**Flood Control Project Maintenance
Levee Inspections**

Maintenance Issue Types Only, Levee Inspection Report By Mile - Spring 2019

Reclamation District No. 2085 Kasson

Waterway	Bank	Unit Miles	Inspection Start/End	Inspector
Unit No. 01 San Joaquin River	Left	5.29	05/09/2019 05/09/2019	Alberto De Leon

Photo 3 of 3 : UCIP_SP_2019_19433_32988.jpg

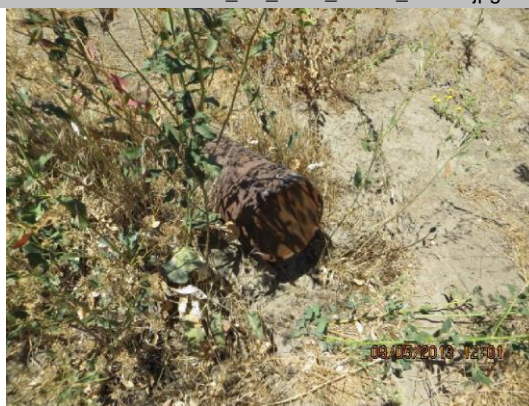
LM Start	3.30	Rating **	M	Issue No.	56 (cont)	
LM End	3.30	Issue Type +	Ma	Location *		
Category	Supplemental			GPS Latitude/Longitude		
				Start		End
Item	DWR UCIP LMA Responsibility			37.693618 °	37.693618 °	
				-121.277639 °	-121.277639 °	
DWR ID	20693					
Comment Code						
Inspector Comment						
FS_ID:19433						
DS_ID:20693						
EP_NO: N/A						
Repair Type: Non-Urgent						
Crossing Status: Found						
UCIP Comments: Pipe appears abandoned and should be done so properly.						
FIELD_STRUCT_DESC: *ABANDONED* 10-inch steel storm drainage pipe through the levee, 4 feet below the crown. T-post marks location of pipe at the landside (LS) toe. Steel plate welded over pipe on the waterside (WS) slope. [Additional Reference(s): USACE San Joaquin O&M Manual 11, 1968, (HLM 3.34), As-Built Drawings available, DWG 7-4-1685].						
FS Date: 9/5/2013

Pipe visible on WS slope. Steel plate welded over end.
